ADDENDUM NO: ONE (1)

PROJECT NAME: Hayden Business Park Development – Phase 1

ENGINEER: Sunrise Engineering, Inc.
201 Commerce Drive, Unit 1
Fort Collins, Colorado 80524

DATE: July 21, 2023

SET NO.	DESIGNED	DRAWN	CHECKED	SHEET NO.	
08834	TJS	TS/JC/DB	TLS	9 of 70	GR01

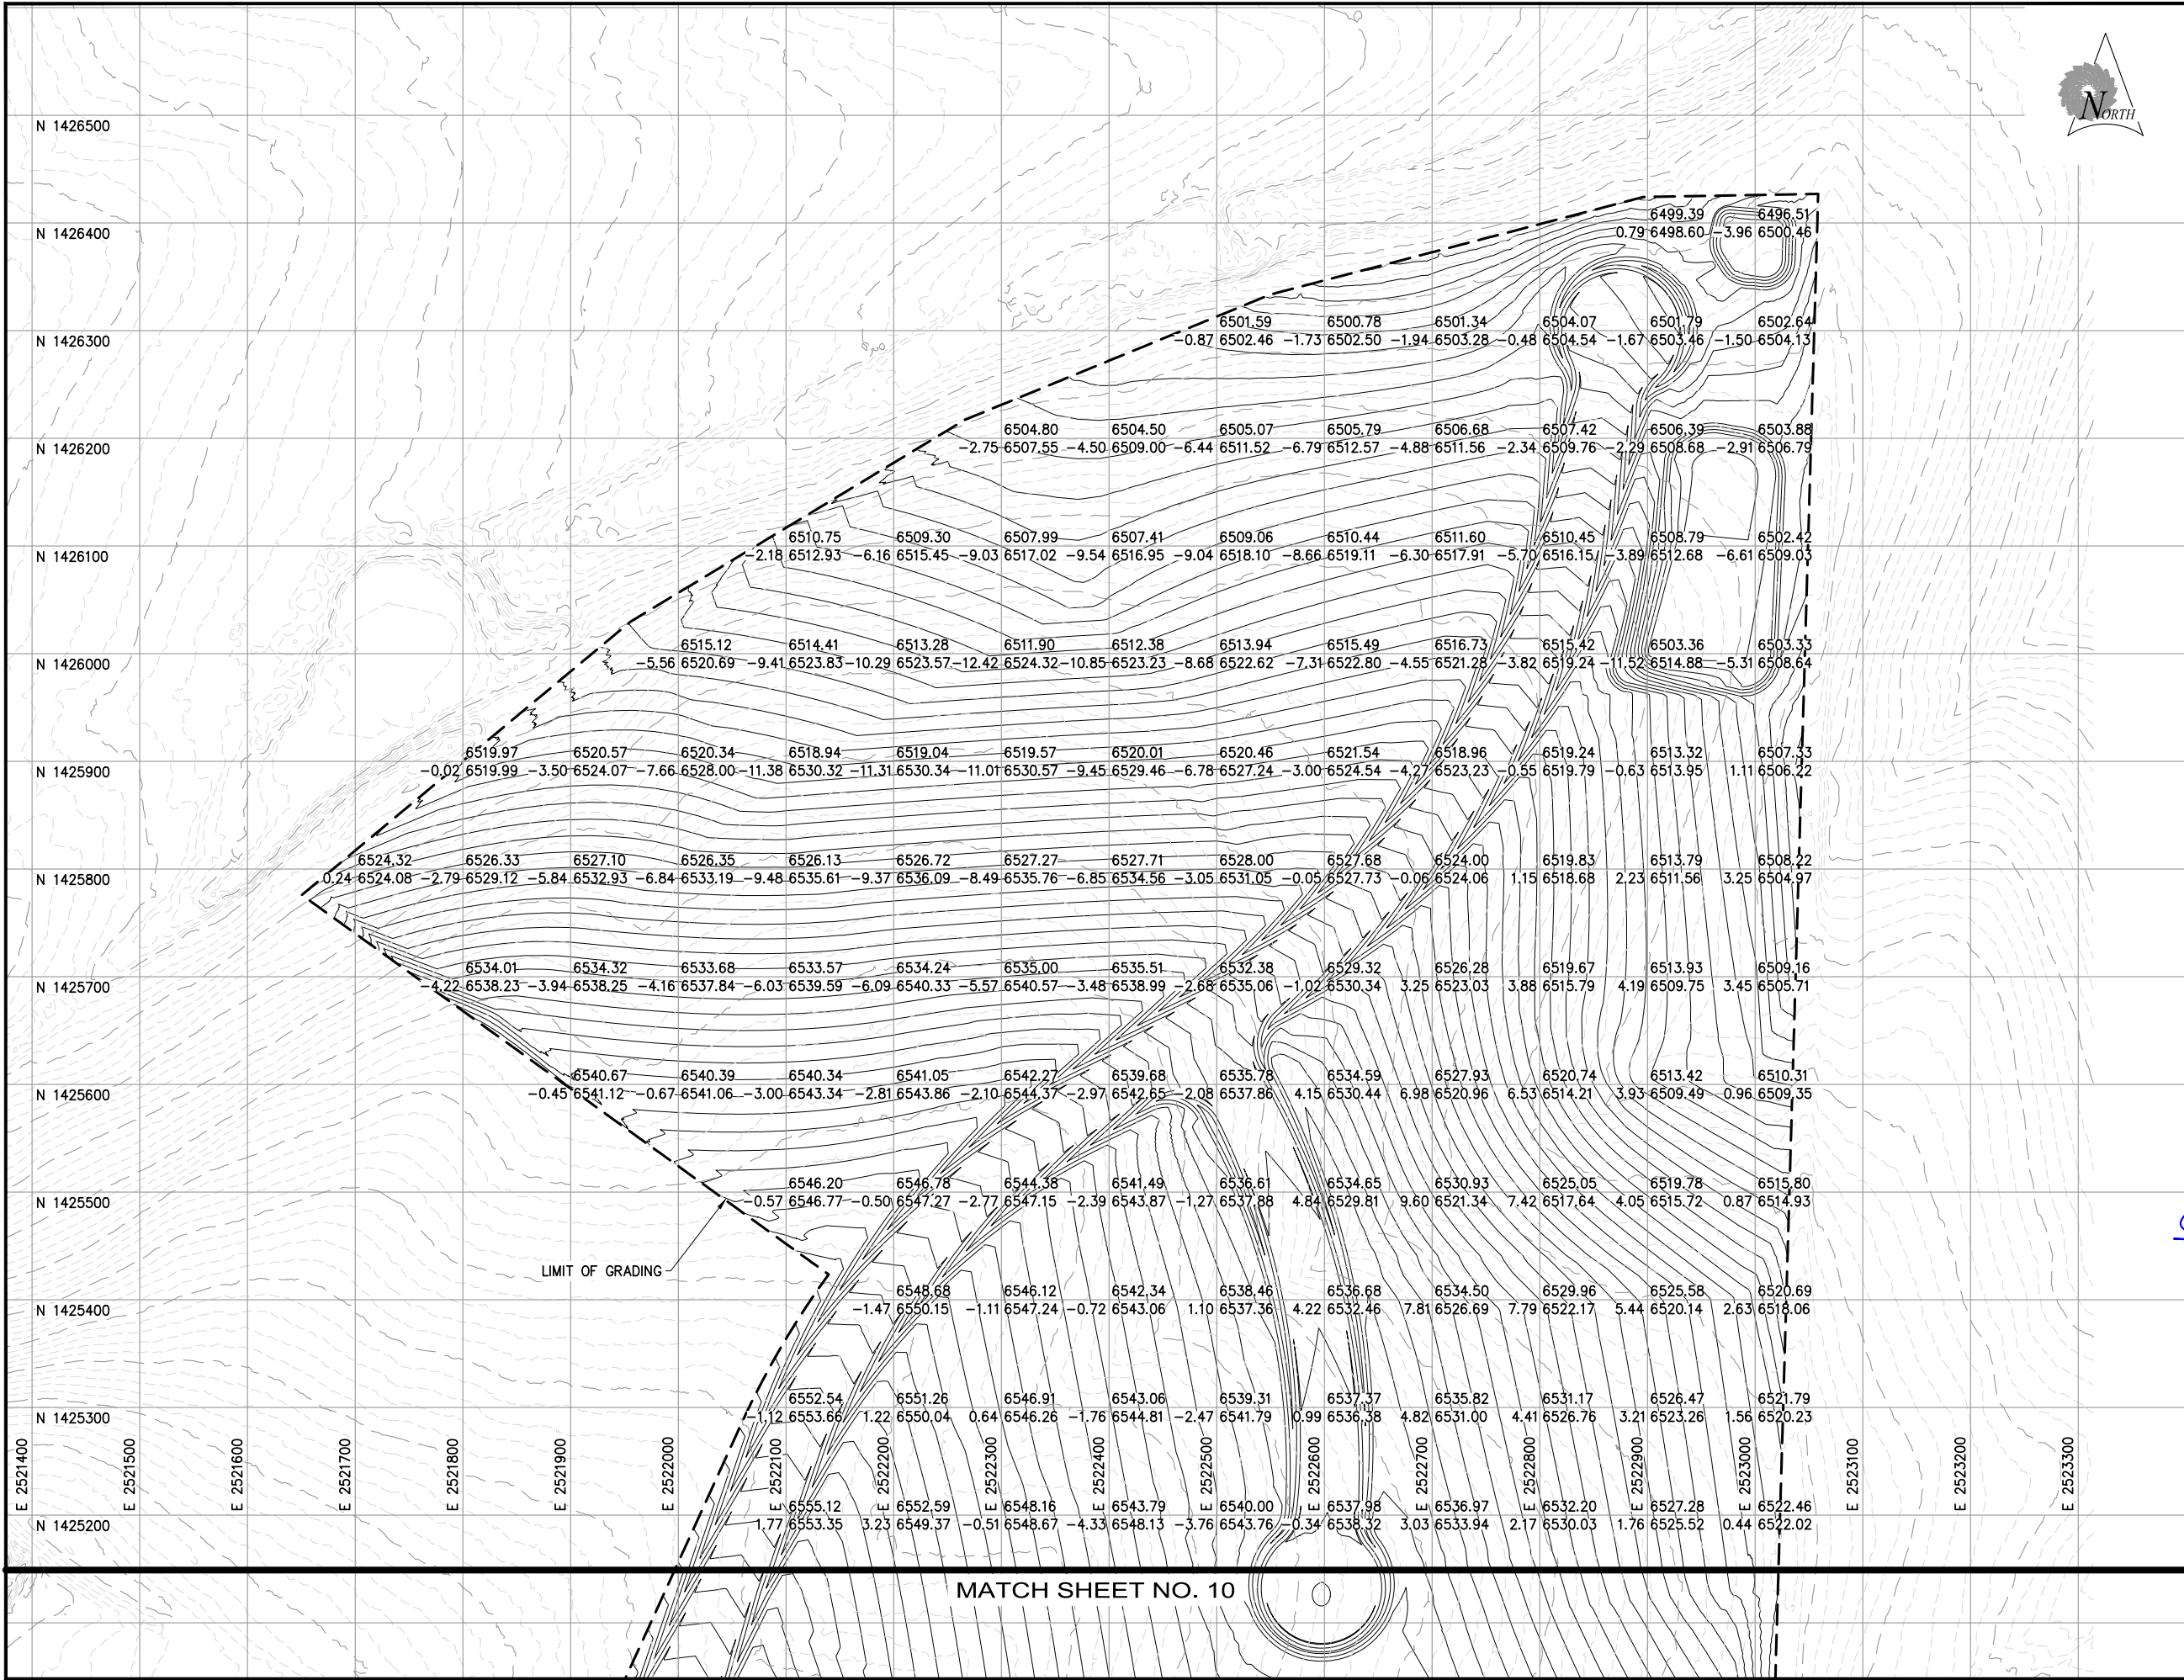
8	When would the notice to proceed be issued?	Project Award is contingent upon receipt of an Army Corps of Engineer's permit. The anticipated Notice of Award is mid-August, 2023.
9	Can the item for dirt quantities be changed from a lump sum to a CY quantity?	<p>No, the payment will remain as Lump Sum. Contractor will be paid per the payment schedule listed in SP 02202.4.1. Contractor shall be responsible for providing a survey surface to prove grading tolerances per SP 02202.3.7.2. Owner and Engineer reserve the right to reduce payment if final overlot grading exceeds these tolerances.</p> <p>Contractor shall be responsible for their own assumptions regarding the quantities shown on GR01 and GR02 (ex: Fill Factor is shown as 1.2).</p> <p>No additional payment shall be made for any material imported/exported from the site.</p>
10	Is a 1.1 shrink factor adequate?	Based on discussions with Bidders and following in-house review, it has been decided to use a fill factor of 1.2. See revised quantities in attached sheets GR01 and GR02.

11	Can the spoils from the off-site sewer line be trucked to the on-site job?	No, the spoils from the off-site sewer will be hauled to a location that will be determined as a part of Addendum #2.
12	Is there a place for spoils to be disposed of?	The spoils will be used in Overlot Grading.
13	Were the spoils from utility installation accounted for in the cut/fill balance?	Yes, utility spoils were accounted for in the cut/fill balance for on-site water and sewer utilities. See replacement sheets GR01 and GR02.
14	Is there an engineer estimate and can the contractors see it?	Yes, there is an engineer's estimate. No, the Town will not share this information at this time.
15	Was topsoil accounted for in cut/fill? Where does material go?	Yes, replace sheets GR01 and GR02 with the attached revised grading plans.

REVISION NUMBER	1
COMMENT	REGRADING
DATE	07-20-2023
REVISION NUMBER	
COMMENT	
DATE	
REVISION NUMBER	
COMMENT	
DATE
